Attachment 2

Mark-ups for the Associated COLA Revisions for 2.5.2 RAIs

Mark-up for FPL Revised Response
to NRC RAI No. 02.05.02-2 (eRAI 5896)

Figure 2.5.2-258a

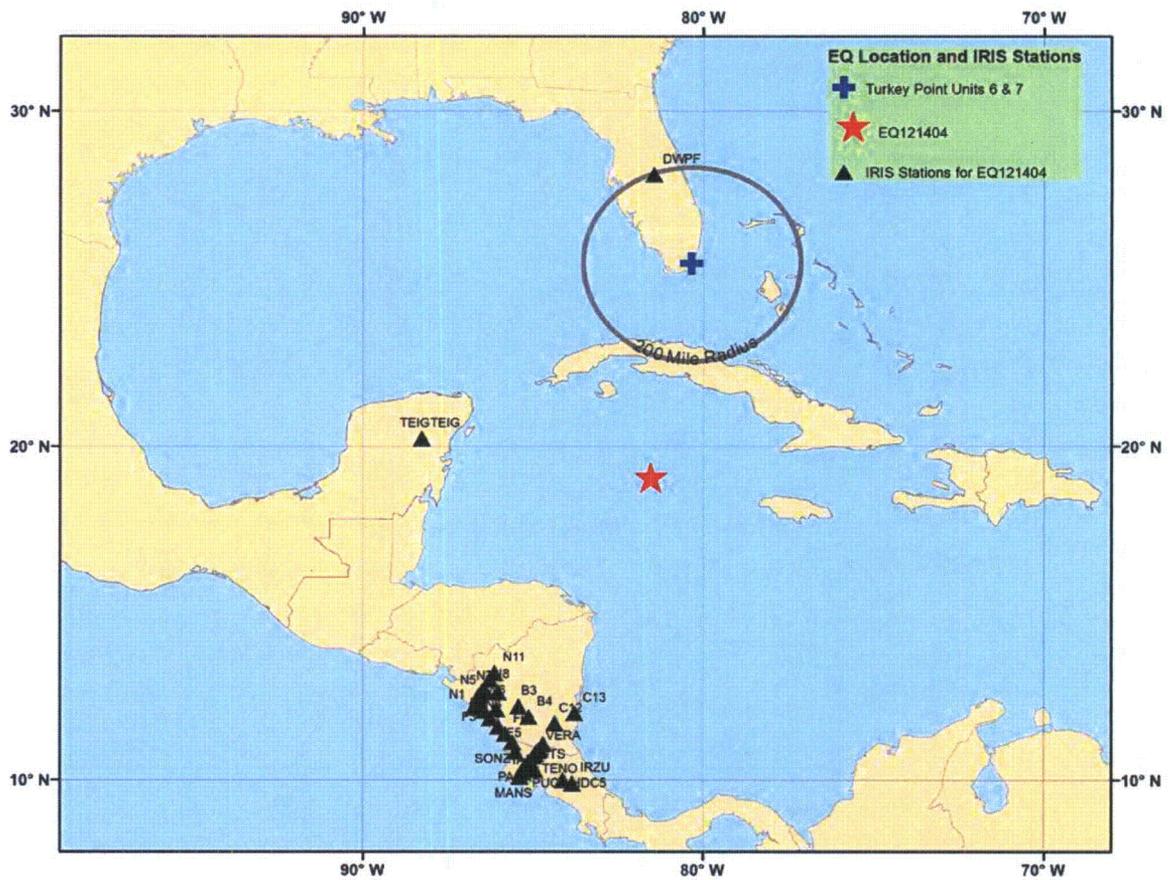
This event occurred in the Caribbean Sea region and its epicenter is shown in Figure 2.5.2-258a along with the Turkey Point Units 6 & 7 site location, and the location of the IRIS stations that recorded this earthquake and were analyzed. Based on the observed station distribution, the IRIS station DWPF located in central Florida has the most applicable source to site path for this comparison. The GMPE curves and empirical data are shown in Figures 2.5.2-258b and 2.5.2-258c for the 1 Hz and 2.5 Hz spectral frequencies. The data point from the DWPF station is highlighted as a solid blue symbol. Overall the empirical data both as recorded and with the site condition correct factors applied falls below the median Caribbean GMPE curve (heavy red line) and has values which that are in the lower distribution range of Caribbean GMPE curves.

Figure 2.5.2-259a

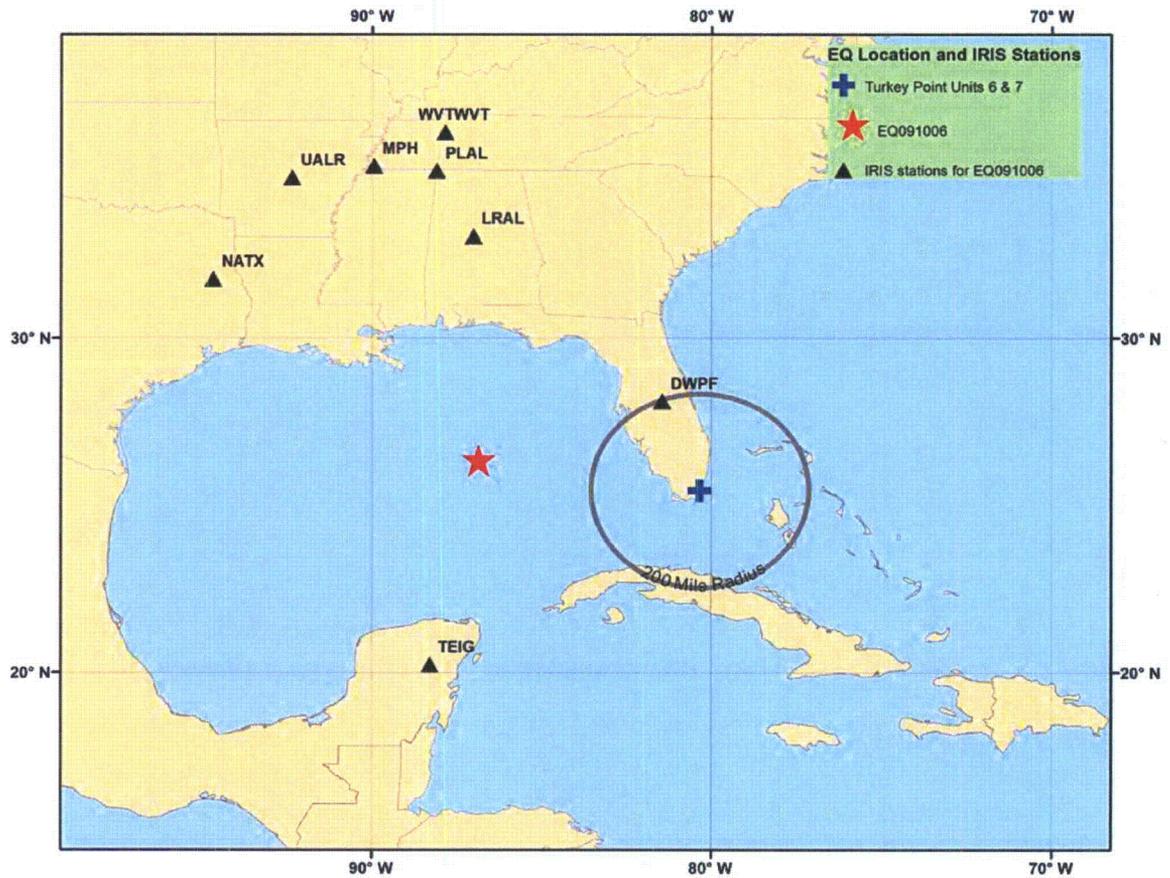
This event occurred in the Gulf of Mexico and its epicenter is shown in Figure 2.5.2-259a along with the Turkey Point Units 6 & 7 site location, and the location of the IRIS stations that recorded this earthquake and were analyzed. Based on the observed station distribution, the IRIS station DWPF located in central Florida has the most applicable source to site path for this comparison. Out of the five earthquakes considered in this analysis, this event has the most consistent tectonic structure between the earthquake and the Turkey Point Units 6 & 7 site and can be considered as the best representative event for events occurring in and around the island of Cuba and being observed in S southern Florida. The distribution of stations in the central United States have has a less applicable travel path azimuth and may show different attenuation properties based on these different tectonic travel paths. The GMPE curves and empirical data are shown in Figures 2.5.2-259b and 2.5.2-259c for the 1 Hz and 2.5 Hz spectral frequencies.

Figure 2.5.2-259b

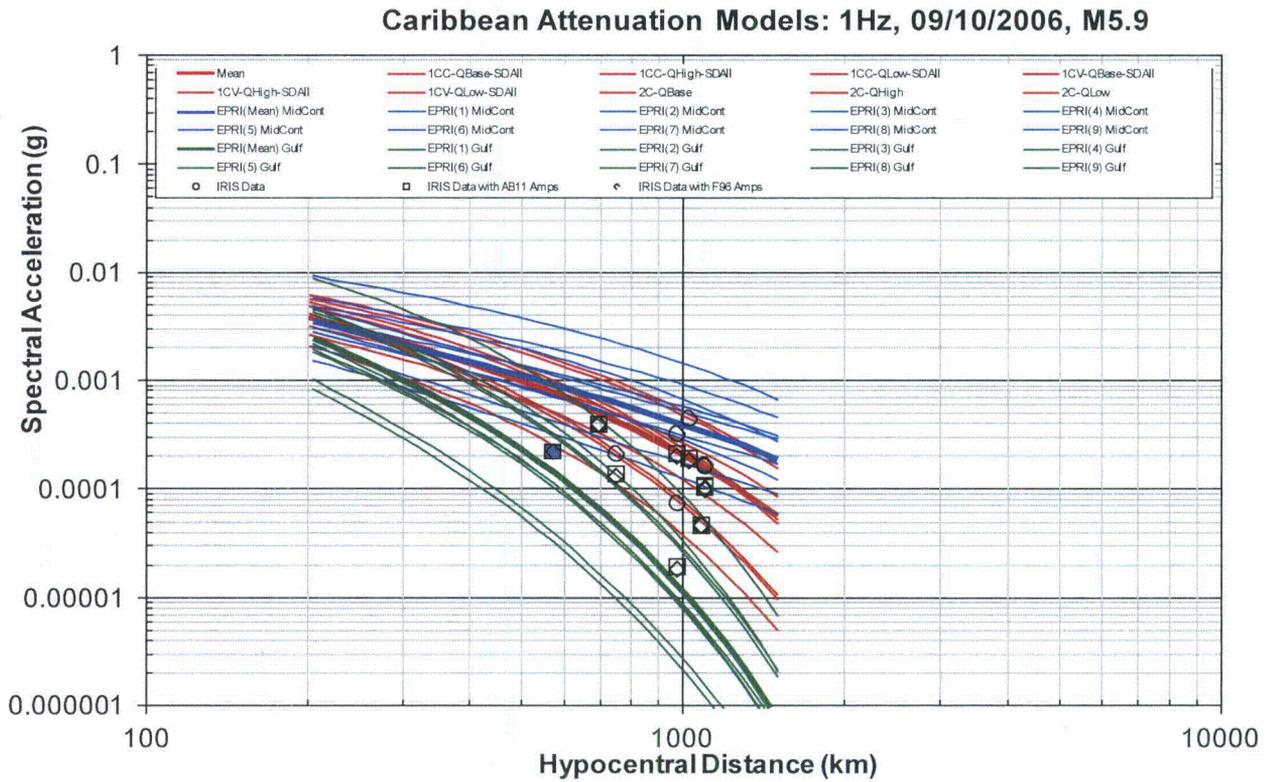
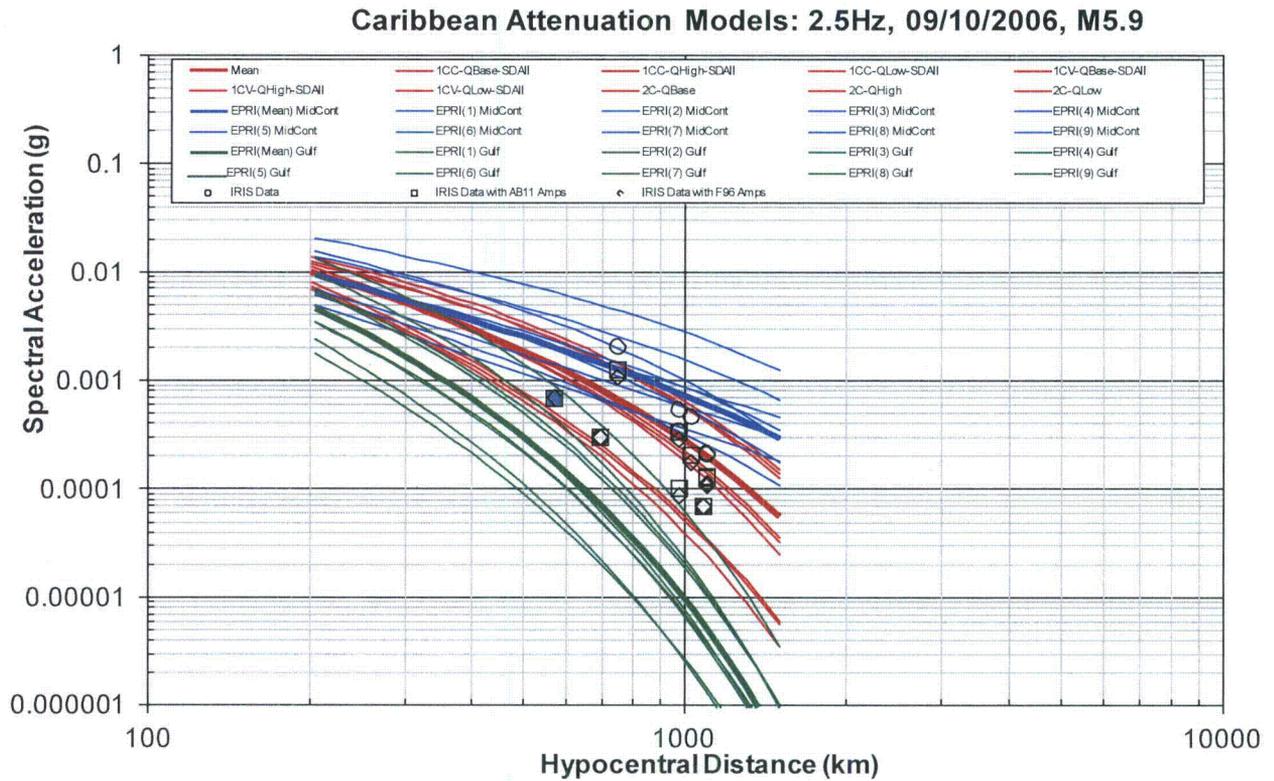
The data point from the DWPF station is highlighted as a solid blue symbol. In general the empirical observations fall within the range of the Caribbean GMPE curves with the single exception of station LRAL (i.e., at a distance of ~~about~~ **approximately 750 km kilometers [466 miles]**) for 2.5 Hz in which the unadjusted empirical data exceeds the highest Caribbean GMPE curve. For this station and frequency, however, the CEUS hard rock adjusted ground motions fall within the range of Caribbean GMPE models which are defined for CEUS hard rock site conditions. It can also be concluded from the comparison plots in Figures 2.5.2-259b and 2.5.2-259c, that the distribution of the current Caribbean GMPE curves adequately captures the range of the empirical data. In addition, the observation from the DWPF station is in the lower range of the Caribbean GMPE curves.

Figure 2.5.2-260a

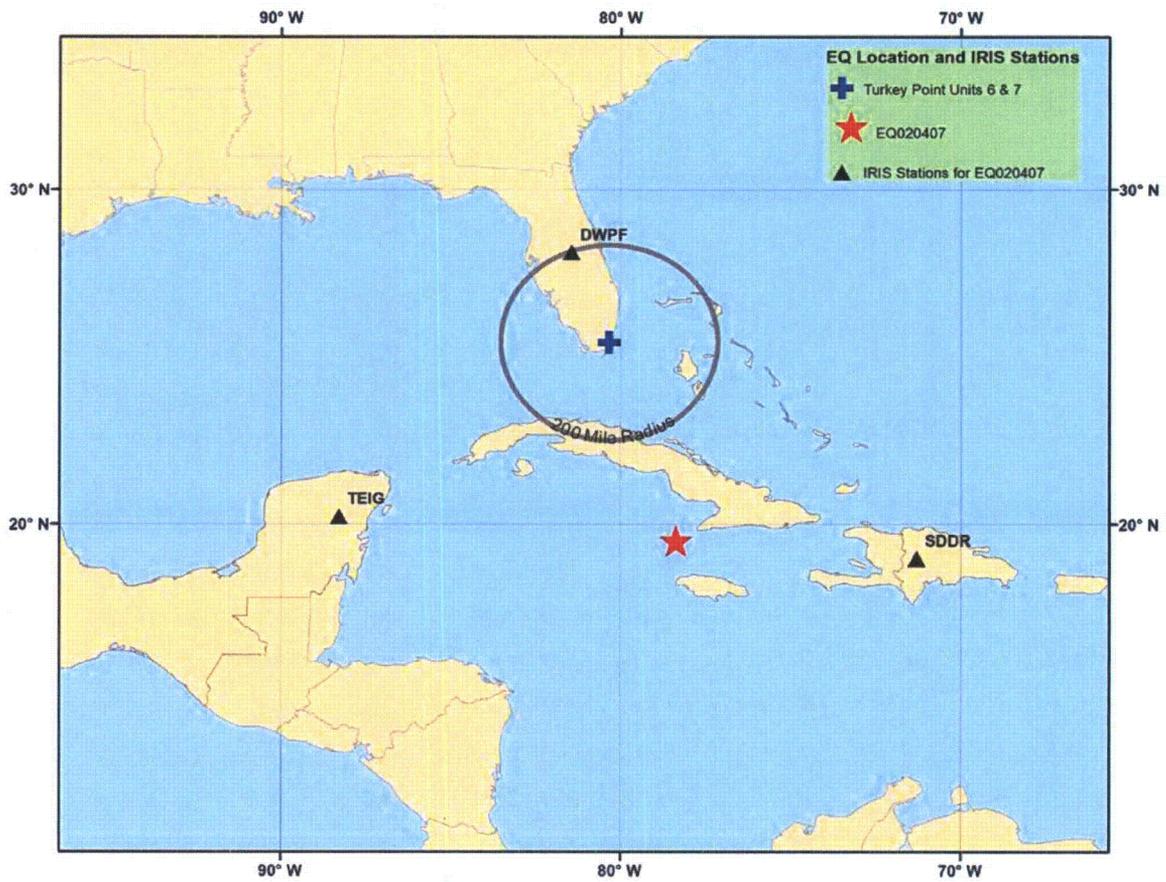
This event occurred south of the island of Cuba and its epicenter is shown in Figure 2.5.2-260a along with the Turkey Point Units 6 & 7 site location, and the location of the IRIS stations that recorded this earthquake **and** were analyzed. Only three IRIS stations were analyzed from this earthquake and their station locations are shown in Figure 2.5.2-260a. Based on the observed station distribution, the IRIS station DWPF located in central Florida has the most applicable source to site path for this comparison. The GMPE curves and empirical data are shown in Figures 2.5.2-260b and 2.5.2-260c for the 1 Hz and 2.5 Hz spectral frequencies. The data point from the DWPF station is highlighted as a solid blue symbol. Overall the empirical data falls below the median Caribbean GMPE curve (heavy red line) and has values **which that** are in the lower distribution range of Caribbean GMPE curves. In addition, the observation from the DWPF station is similar to the lowest Caribbean GMPE curve or lower.

Figure 2.5.2-261a

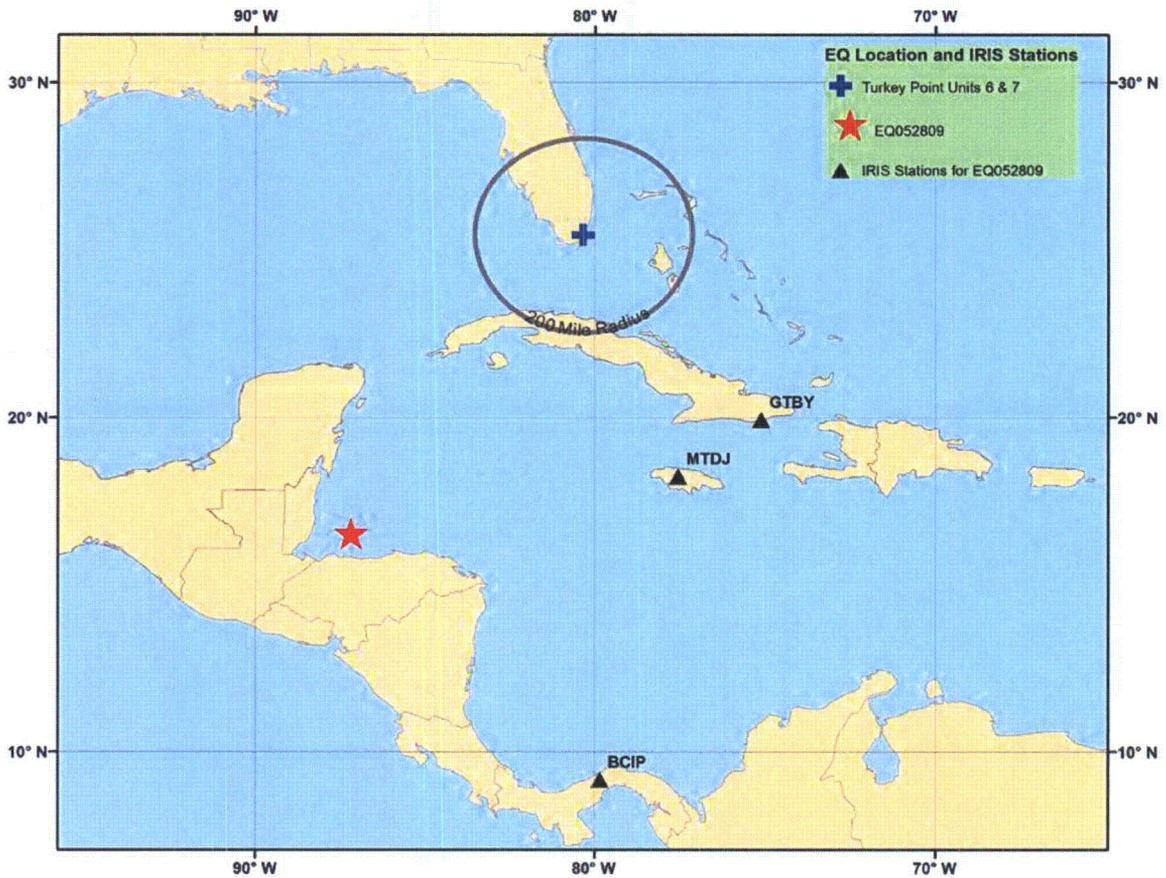
This event occurred north of Honduras in Central America and is the largest earthquake in the suite of five events analyzed in this sensitivity study. The location of its epicenter is shown in Figure 2.5.2-261a along with the Turkey Point Units 6 & 7 site location, and the location of the three IRIS stations that were analyzed. Based on the azimuths from the earthquake to the three IRIS stations, none of the associated seismic ray travel paths are ideal for this comparison study. The **GMPE attenuation** curves and empirical data are shown in Figures 2.5.2-261b and 2.5.2-261c for the 1 and 2.5 Hz spectral frequencies. The comparisons provided in the figures indicate that the empirical data from this earthquake are lower than any of the Caribbean **GMPE attenuation** curves.

Figure 2.5.2-262a

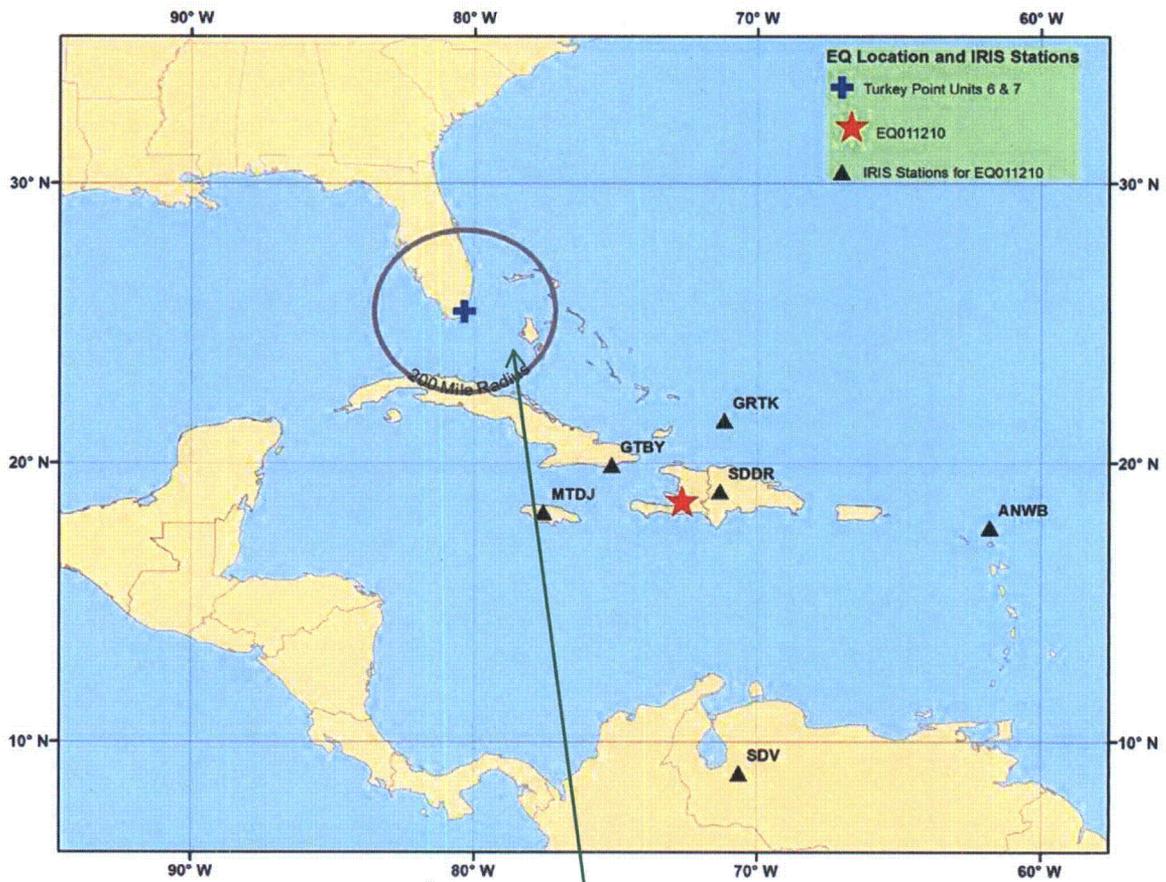
The Haiti earthquake is the most recent event in this suite of five earthquakes analyzed. The epicentral location and the suite of IRIS stations analyzed are shown in Figure 2.5.2-262a. Note that the data from the DWPF was not available for this earthquake. For the SDV station, only one single horizontal component was available and thus was not included in the comparison which was based on the geometric mean of two horizontal component ground motions. The large distance and undesirable azimuthal direction away from ~~Southern~~ southern Florida for this station from this earthquake provides an additional justification for not including this station in the comparison. The GMPE curves and empirical data are shown in Figures 2.5.2-262b and 2.5.2-262c for the 1 Hz and 2.5 Hz spectral frequencies. The data point from the OTAV station is highlighted as a solid blue circle. Overall the empirical data falls in the lower range or lower than the Caribbean GMPE attenuation curves. In addition, the observation from the OTAV station is significantly lower than the entire range of the Caribbean GMPE curves.

Iris Station OTAV was not removed in COLA Revision 5

Figure 2.5.2-263

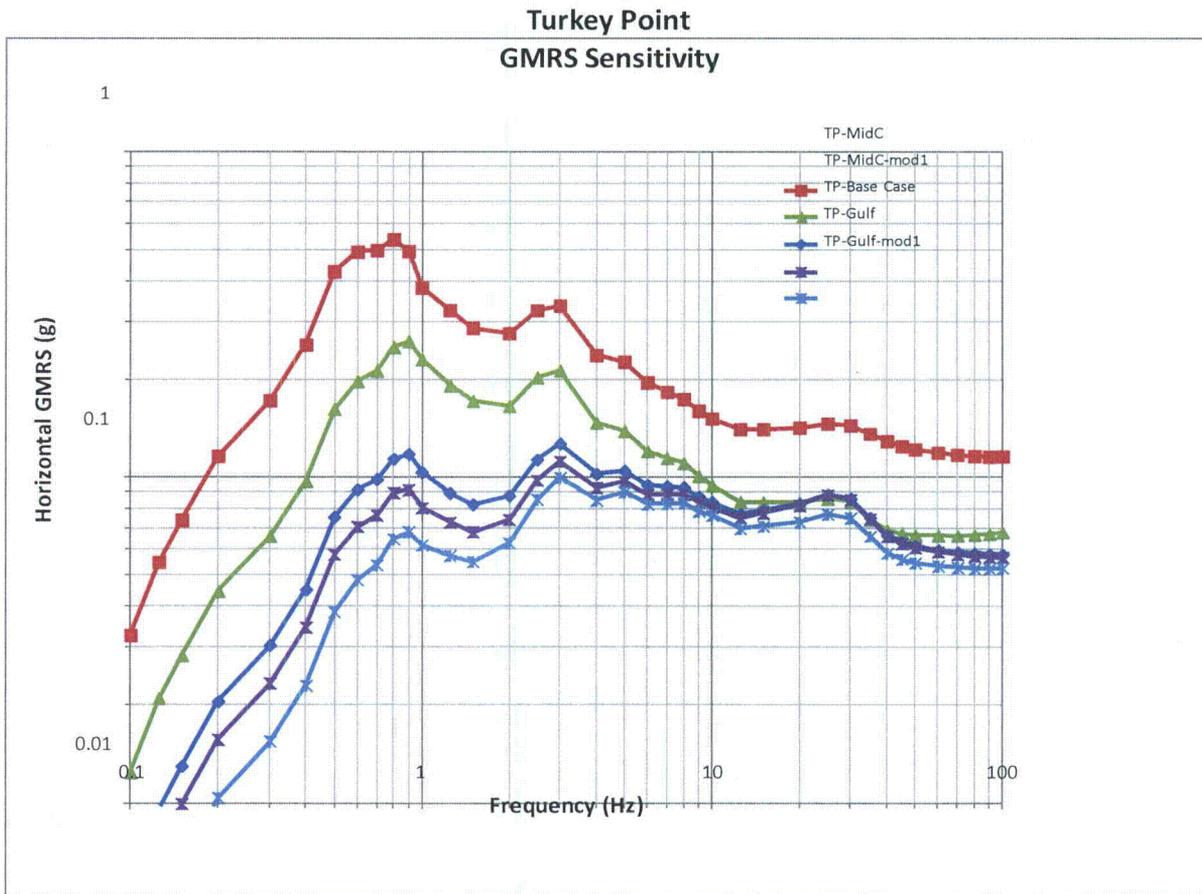
horizontal GMRS are plotted in Figure 2.5.2-263 and are developed using the site amplification factors. In general, the GMRS results using the EPRI Gulf Coast GMPEs are equal to or lower than the results using the Caribbean GMPE (i.e., indicated as Base Case in Figure 2.5.2-263). For the EPRI Mid-continent GMPE, the opposite result is concluded in which the GMRS values exceed the GMRS values using the Caribbean GMPE models, however, based on the previous additional sensitivity, the EPRI Mid-continent models predicts higher ground motions than the empirical ground motions and as such may not be applicable for the modeling of ground motion attenuation for seismic sources in this Caribbean region and the Turkey Point Units 6 & 7 site location in southern Florida.
